NEW MEXICO
ENVIRONMENT DEPARTMENT

Hazardous Waste Bureau

**RE: REPLACEMENT PAGES, QUARTERLY PRE-REMEDY MONITORING AND SITE INVESTIGATION REPORT FOR JANUARY-MARCH 2011, BULK FUELS FACILITY SPILL, SOLID WASTE MANAGEMENT UNITS ST-106 AND SS-111, MAY 2011
KIRTLAND AIR FORCE BASE, EPA ID# NM9570024423
HWB-KAFB-11-008**

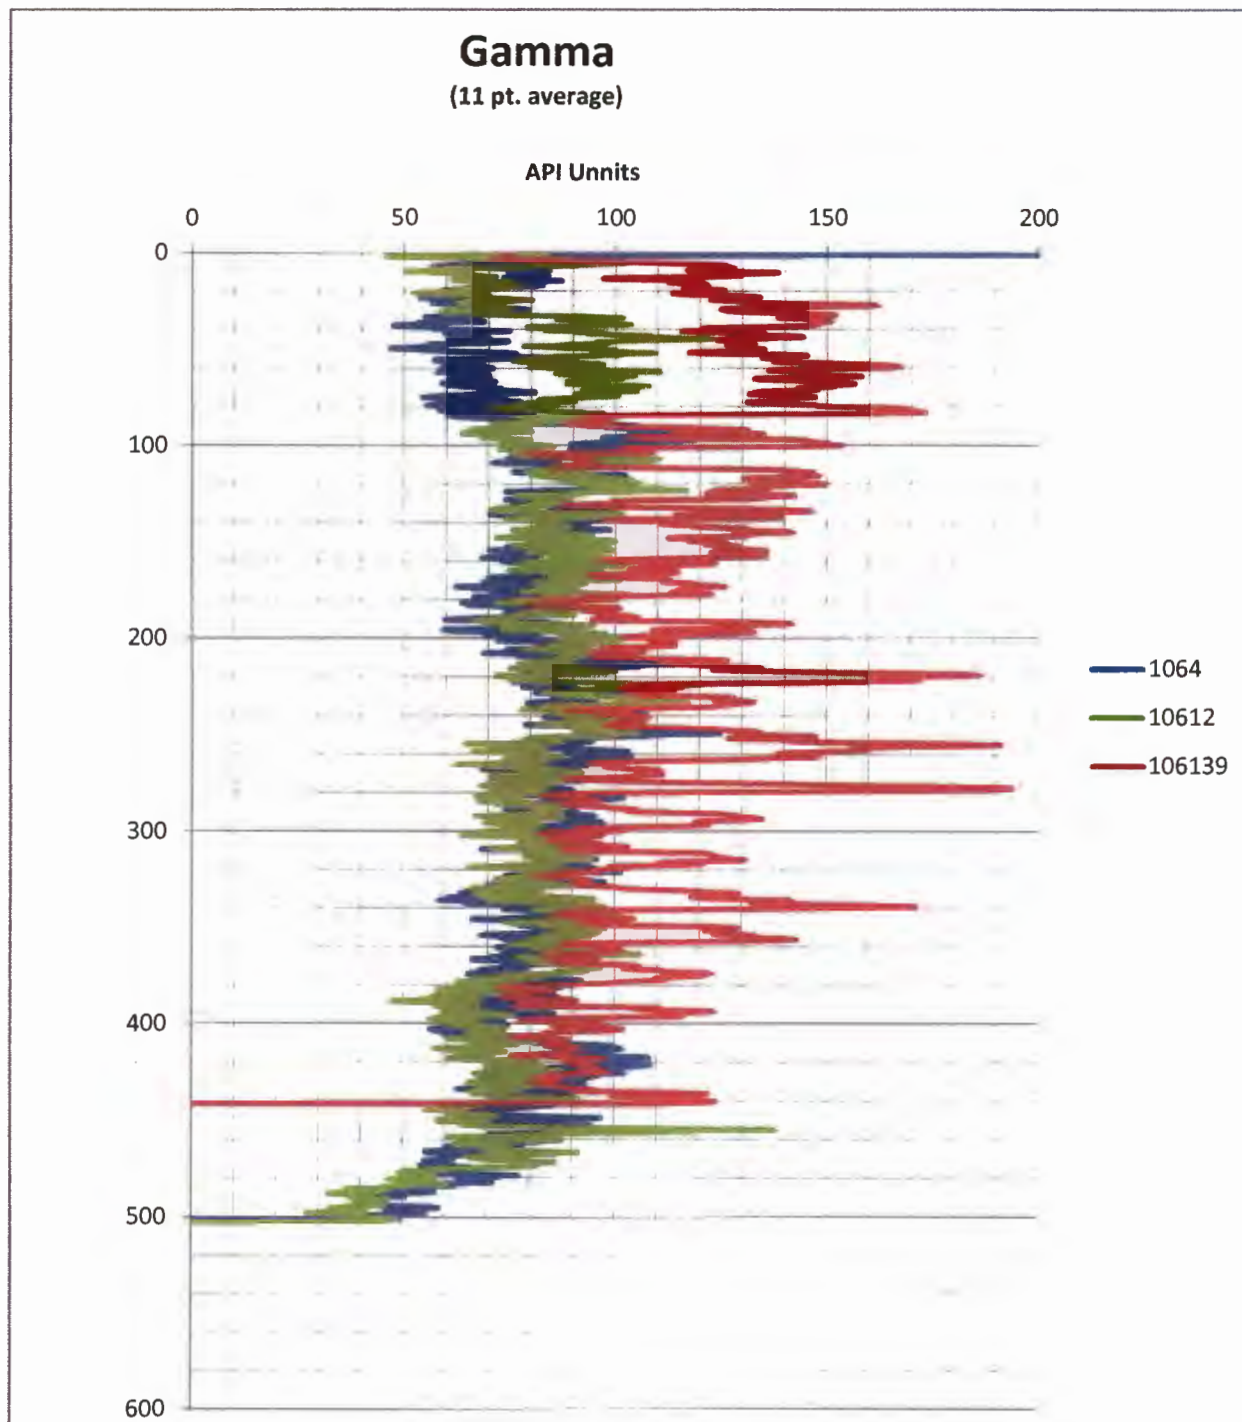
1. Figure 8 of this letter shows the gamma logs from two groundwater monitoring wells (KAFB-1064 and KAFB-10612) situated about 300 feet apart, with a soil-vapor monitoring well (KAFB-106139) located between them. There is a significant difference between the logs generated for the groundwater monitoring wells and that for the soil-vapor monitoring well. The soil-vapor well exhibits many gamma peaks and an overall higher background count than the nearby groundwater monitoring wells. Given the proximity of the three wells, these differences may be related to well construction and not to lithologic differences. However, the gamma peaks do not necessarily correspond to the well construction details. Similarly, the neutron logs also exhibit different characteristics between the groundwater monitoring wells and the soil-vapor well. Provide an explanation, if possible, as to why the logs differ.

Figure 9. Induction and neutron logs from KAFB-10618. Note unusual characteristics of the short normal induction log (labeled ShtRes_F).

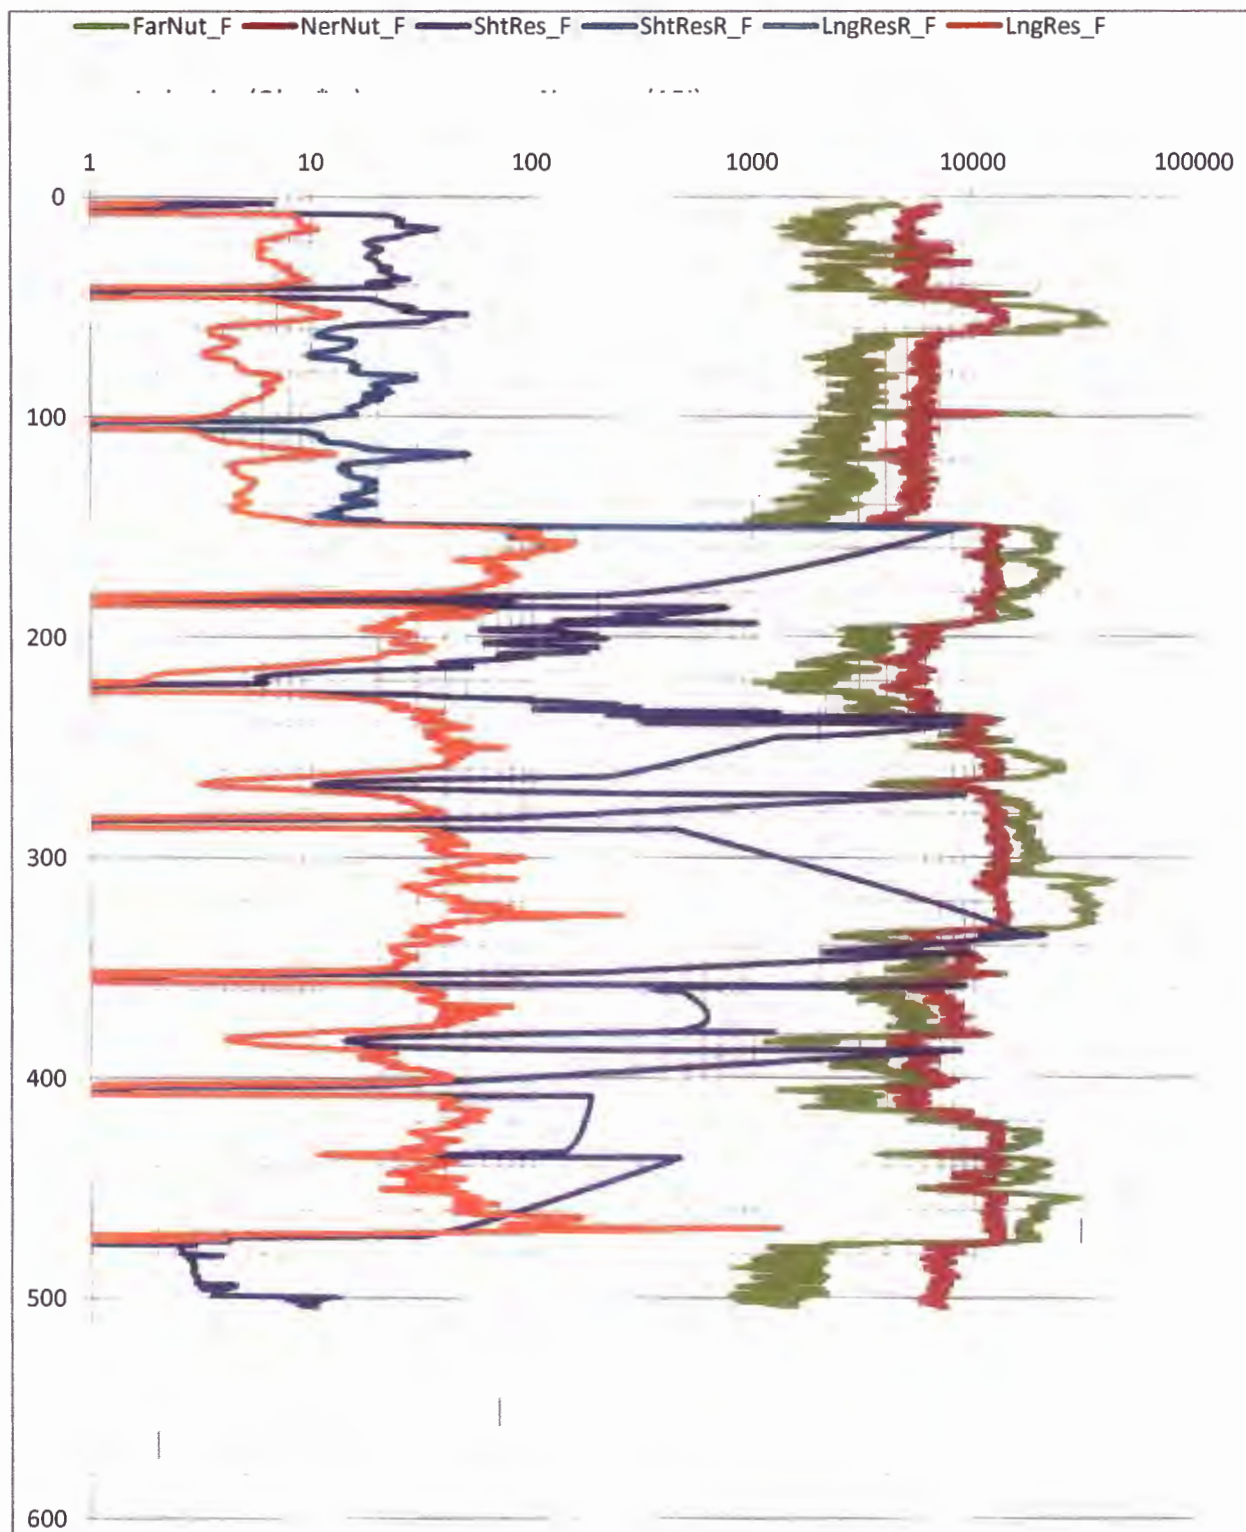
2. In addition, NMED notes that the short normal induction log for KAFB-10618 (see Figure 9 of this letter) is unusual in shape, suggesting a failure of the instrument or other error. While the Permittee's contractor verbally mentioned there was a problem inherent with that specific well at the July 12 meeting, the Permittee must provide a discussion of what the Permittee has done to identify the problem, correct the problem, and acquire reliable information from that well.
